RE: Montague Wind Power Facility, Amendment Determination Request (Proposed Site Boundary Additions)

Staff Evaluation of the Montague Wind Power Facility Amendment Determination Request and Determination

Amendment Determination Request for Montague Wind Power Facility – Phase 1

Figure 1: Proposed Modifications to Approved Site Boundary

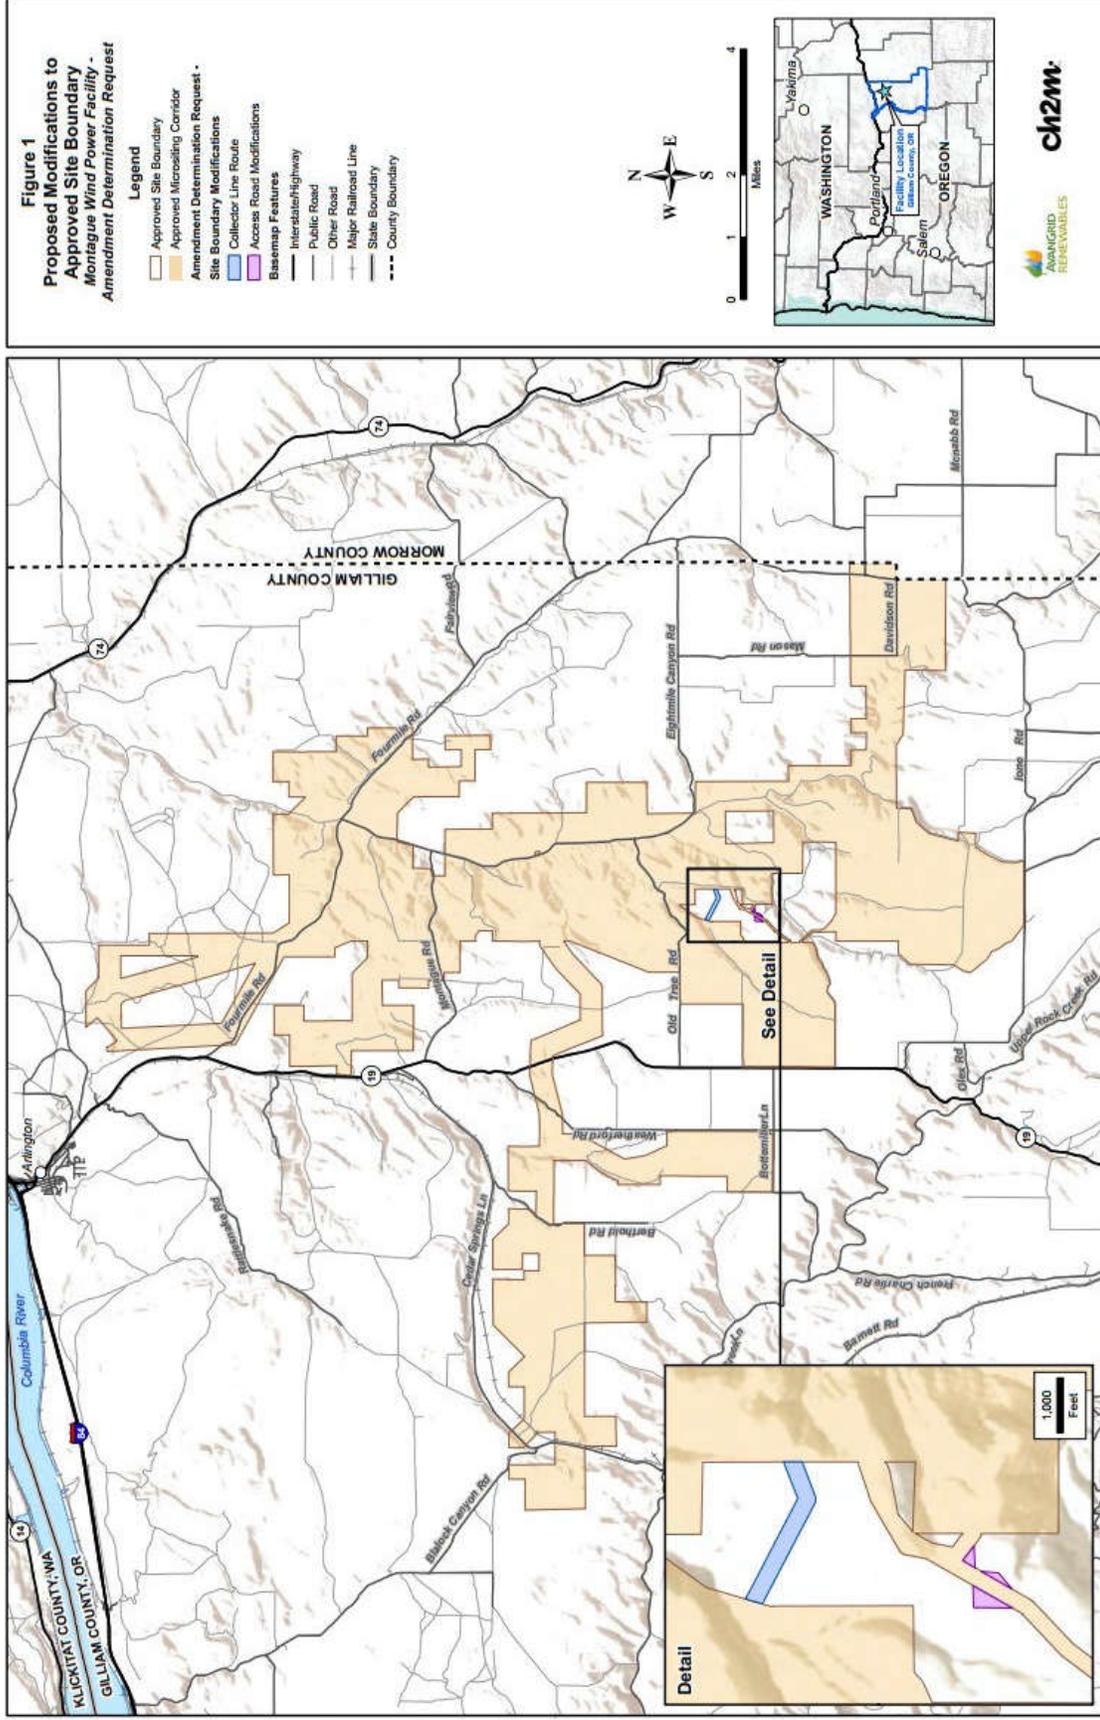
In the ADR, the certificate holder proposes to add approximately 25.8 acres to the facility's site boundary in which it would construct and operate; (1) a modification to an access road between the G turbine string and the H turbine string to better accommodate farming practices based on landowner requests, and (2) more direct below-ground electric collector lines between the H turbine string and the Phase 1 collector substation.² The access road segment would extend approximately 1,056 feet in length, and the collector lines would total approximately 2,830 feet in length and would be underground, both proposed to be sited within the proposed site boundary expansion areas. Both the road and the collector line are re-routed segments that the certificate holder is otherwise authorized to construct in different locations. The ADR is included below, as Attachment 1. See Figure 2 of the Attachment for details on the proposed collector line re-route. Attachment 2 within the ADR has details of the proposed access road modification design. As shown on Table 2 of the ADR, the requested collector line route would be slightly shorter in length and would use fewer overhead poles than what Montague is currently authorized to construct. After installation of the underground collector line, the ground would be restored.

The proposed access road modification would cross an area previously excluded from the site boundary because, as described in the ADR, the land was previously under lease control by a different developer. The certificate holder acquired the rights to this land, and as shown on Figure 1, the proposed access road and collector line routes would provide more direct access to facility components. The certificate holder utilized landowner feedback when designing the three proposed modified access road routes, and ultimately decided that "Option 3" would be primary design option. The ADR further clarifies that Option 3 would "better align with the north-south plowing of rows within the existing wheat fields."³ The proposed access road segment would "temporarily be widened to 80 feet" during construction to provide adequate transport paths for crane operation, temporarily disturbing approximately 1.455 acres of Category 6 (CAT 6) developed-dryland wheat farmland. After construction, the access road would be reduced to 20 feet wide, and would result in a permanent impact of .48 acres to the CAT 6 developed-dryland wheat farmland.

The Department agrees with the certificate holder’s evaluation under OAR 345-027-0050 and finds that the proposed facility modifications included in this Amendment Determination Request do not require a site certificate amendment. The Department concludes that the proposed facility modifications would not cause a significant adverse impact to a resource protected by EFSC standards, and would not substantially impair the certificate holder’s ability to comply with site certificate conditions. Compliance with applicable EFSC Standards, State and local laws, rules, and ordinances would not be expected to be affected by the proposed facility modifications. Based on the findings of fact, the Department determines that the proposed site boundary additions and facility modifications would not require a site certificate amendment.

Figure 1
Proposed Modifications to
Approved Site Boundary
Montague Wind Power Facility -
Amendment Determination Request

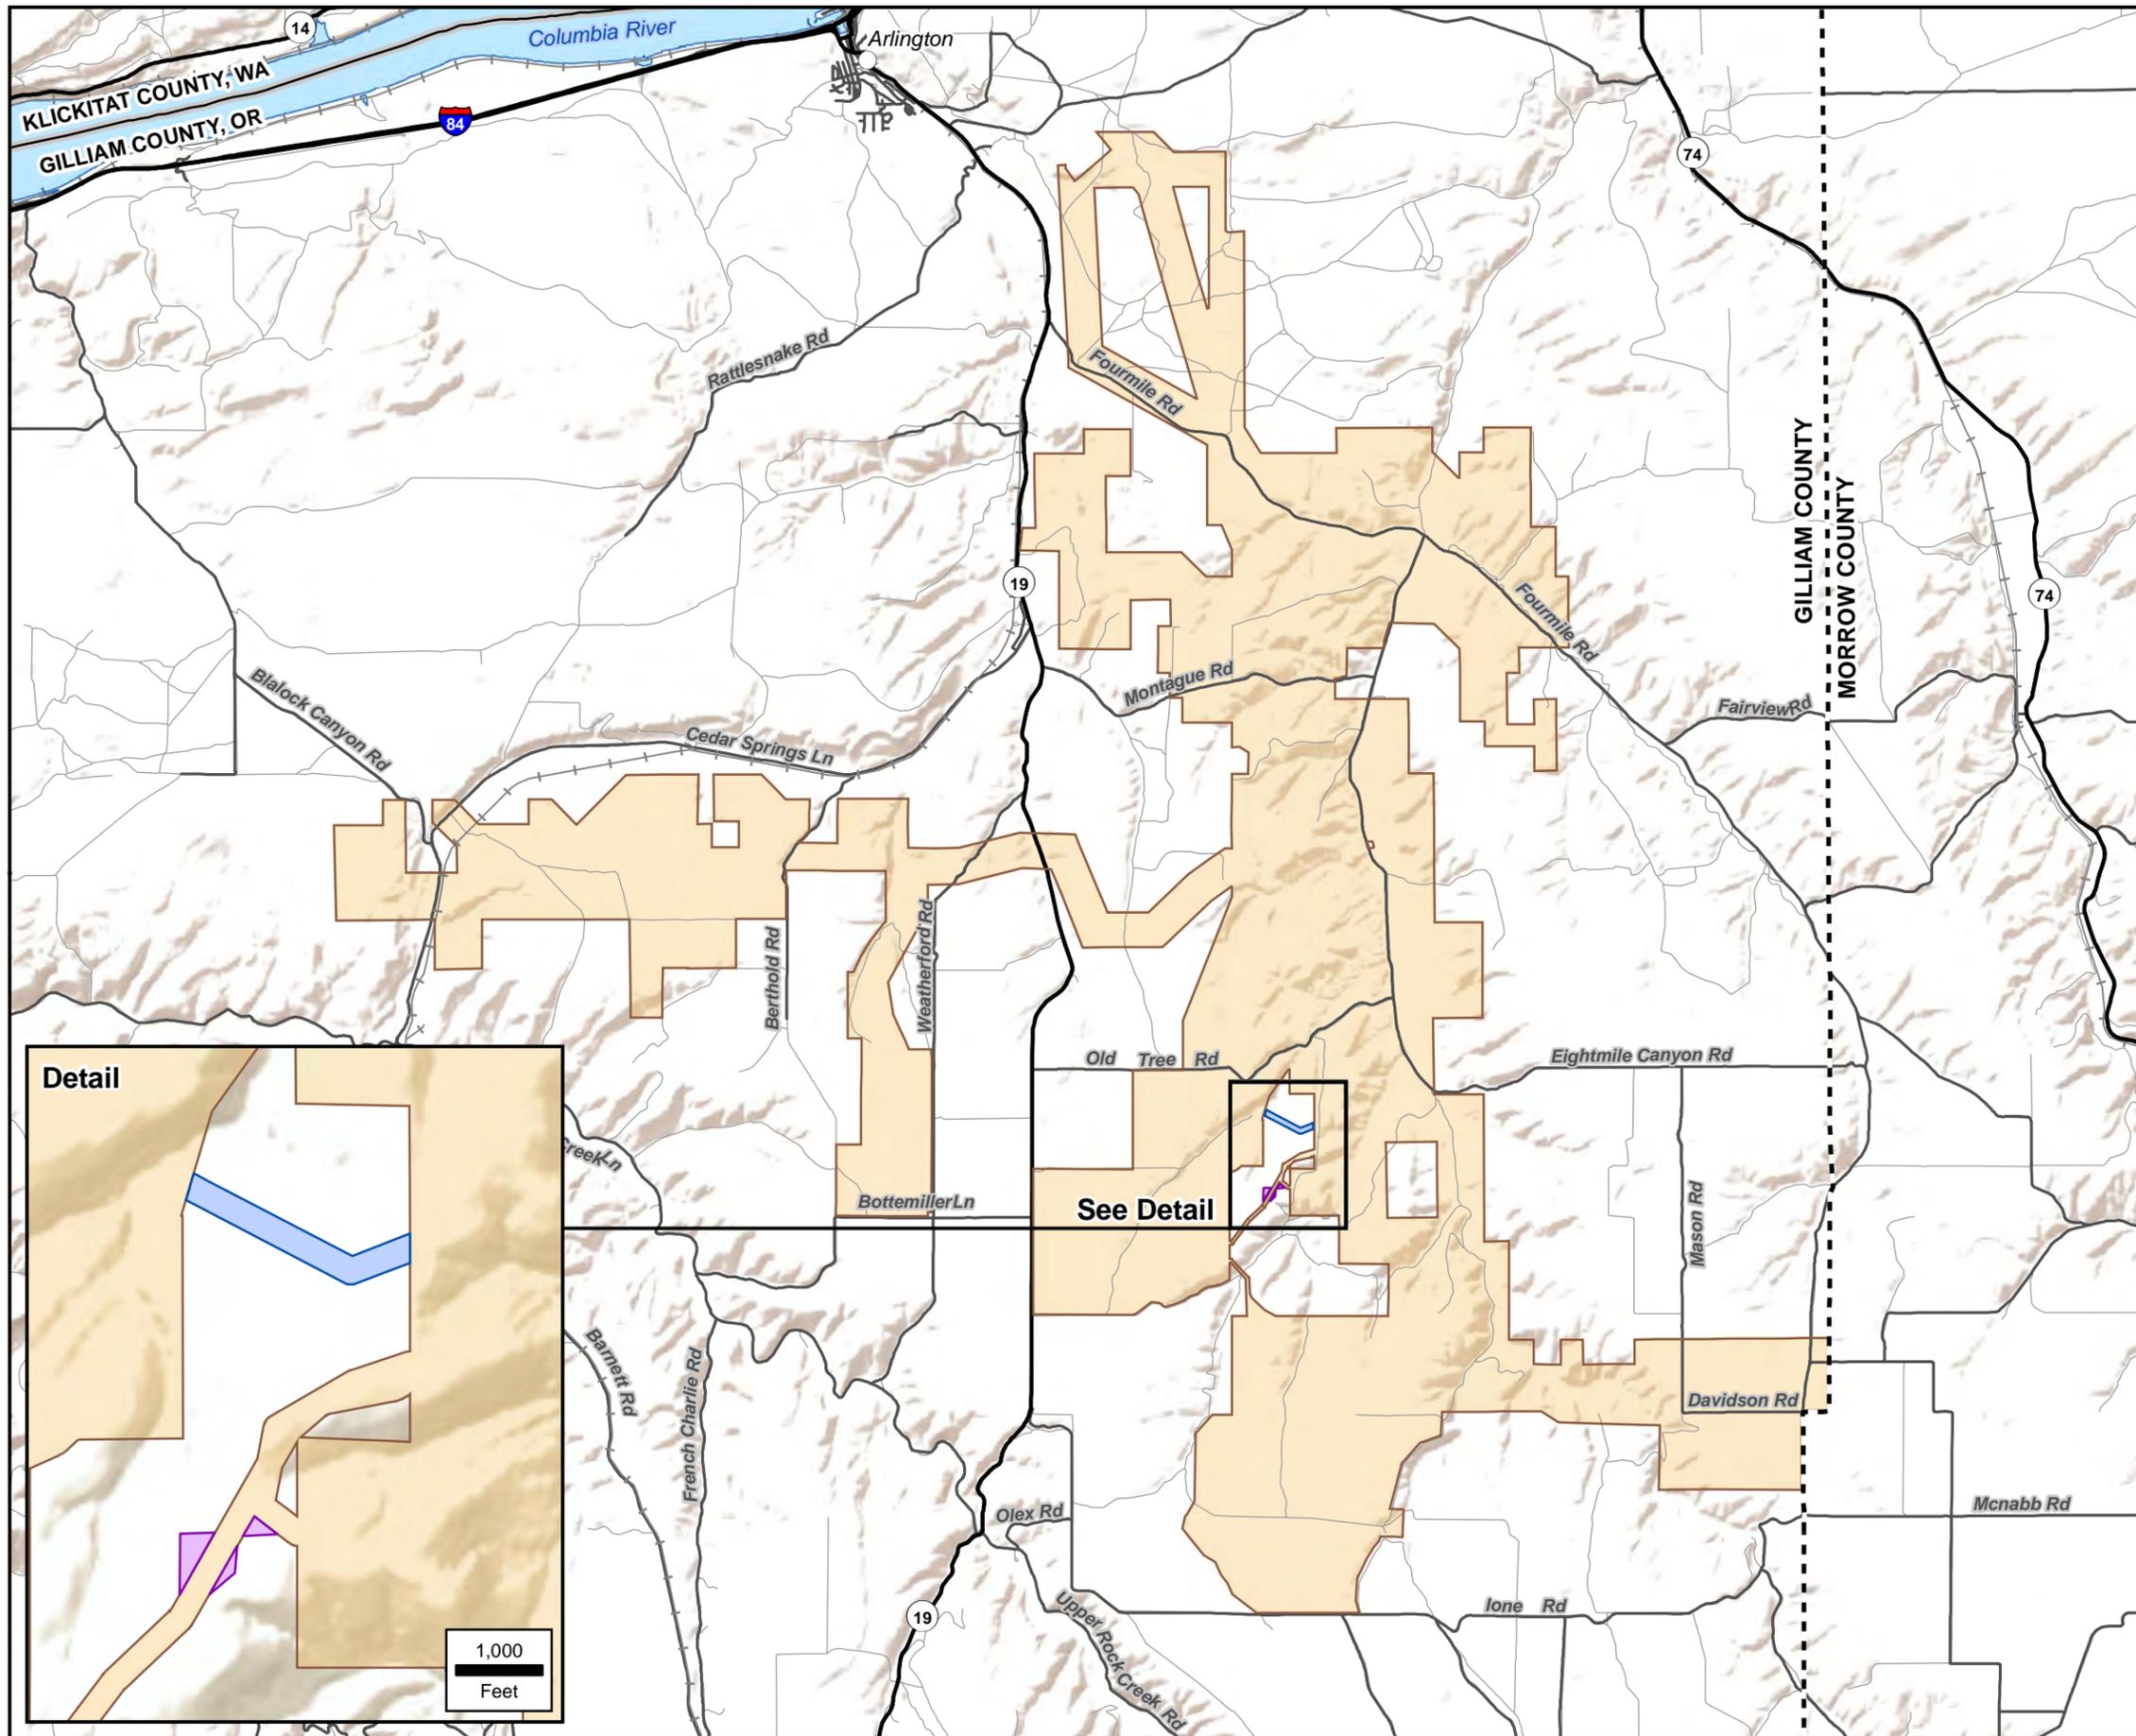
As shown in blue (“Collector Line Route”) on Figure 1, Montague will add approximately 20.6 acres to the approved site boundary for a collector line route between the H-string turbines and the collector substation. This area includes a 320-foot-wide corridor along a 2,830-foot-long underground collector route outside the site boundary. From turbine H6, Montague would install two circuits of buried collection lines across about 700 linear feet of the Crum Ranch property and then about 3,000 linear feet across Weedman Ranch property before transiting to an overhead line on Athern Ranch property for 2,080 feet to the collector substation (see Figure 2). Installation of buried collector outside the approved site boundary would occur in the same manner as previously approved in the Final Order⁶, and have similar or less impacts to a comparable route within the approved site boundary (Table 2).

As shown in purple (“Access Road Modifications”) on Figure 1, Montague seeks to add approximately 5.2 acres to the approved site boundary and micrositing corridor to modify the access road segment from the G turbine string to the H turbine string across the Weedman Ranch property. This access road corridor was previously added to the site boundary as part of Change Request 3⁷. Now Montague is considering three different alignments for the access road to turbines H8 and H9 (see Attachment 2). These options are intended to address the landowner’s request related to the direction of plowing, but are slightly outside of the corridor previously defined in Change Request 3. The length of the access road to the H turbine string would generally be the same with the each of the alignment options (within 500 ft).

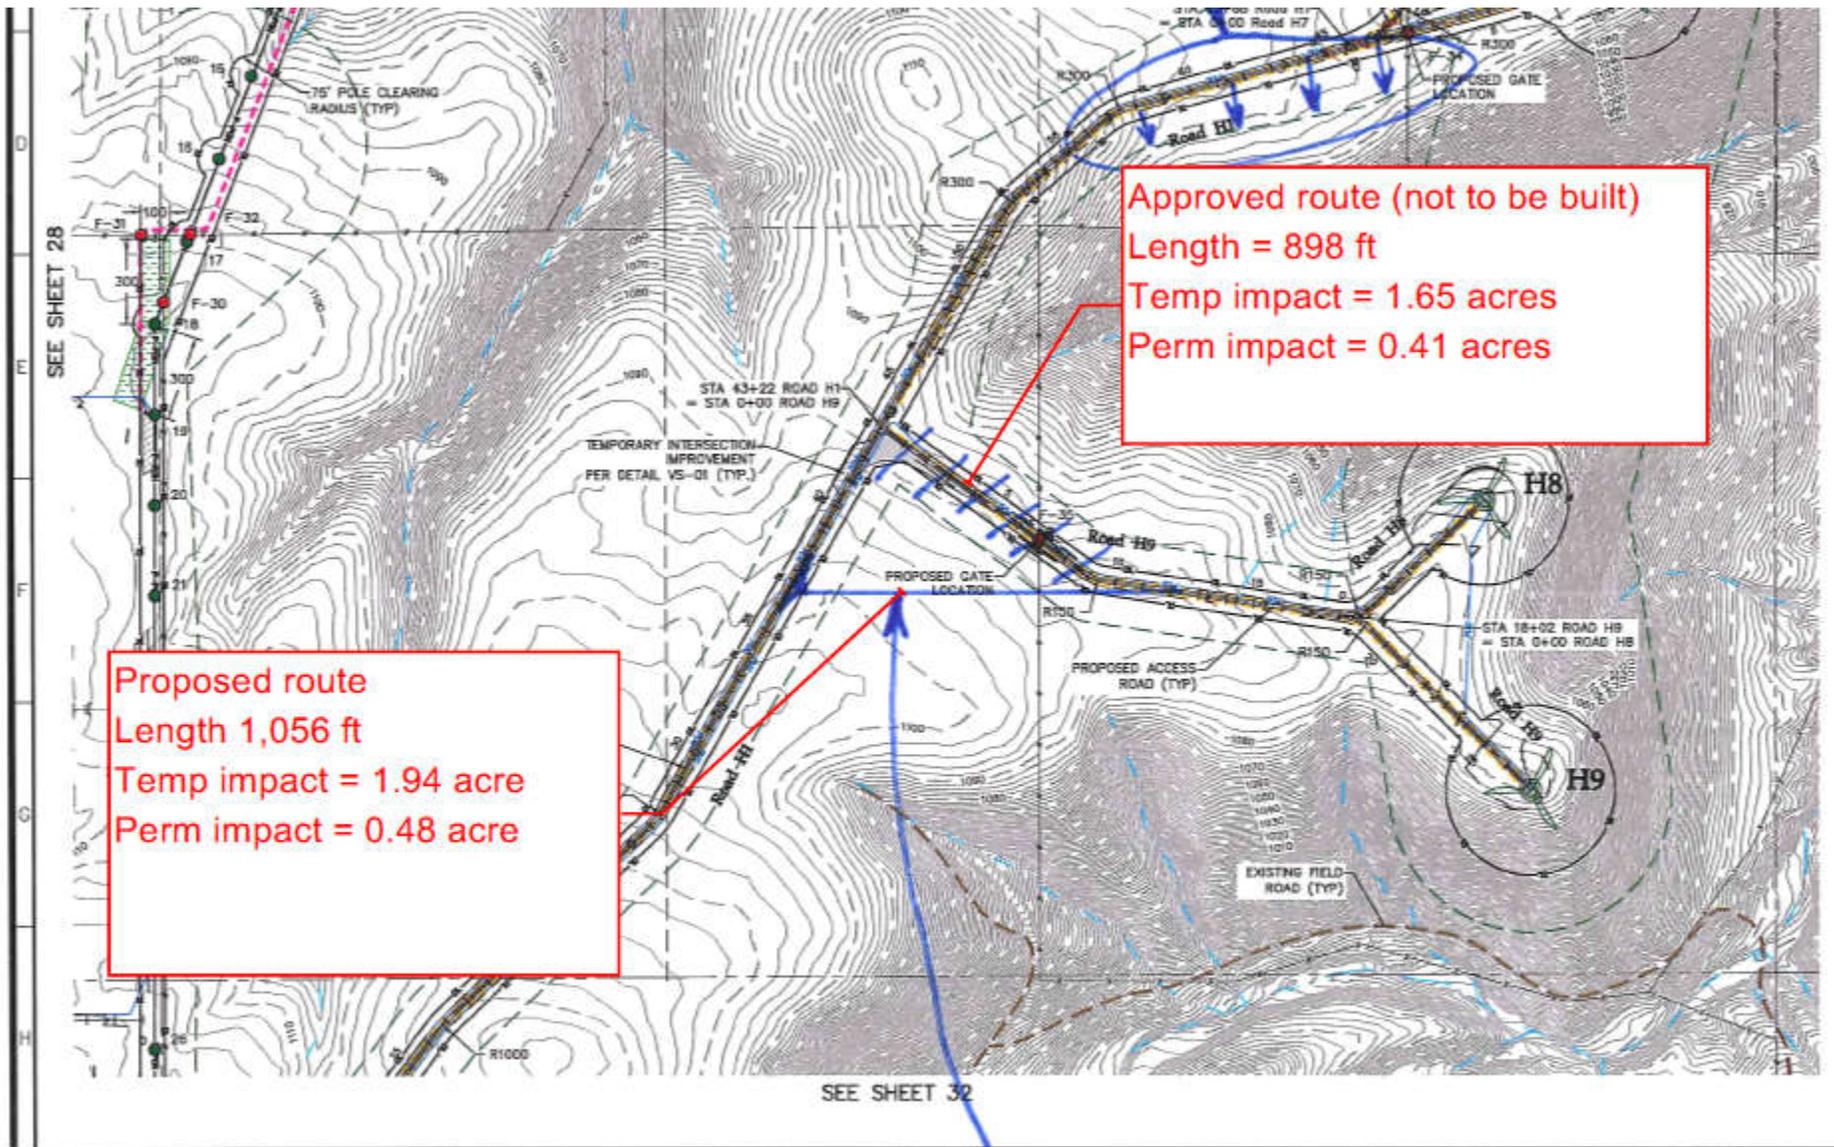
Chase,
Here is my estimate for impacts related to the road realignment.

Approved route (not to be built)
 Length = 898 ft
 Temp impact = 1.65 acres
 Perm impact = 0.41 acres
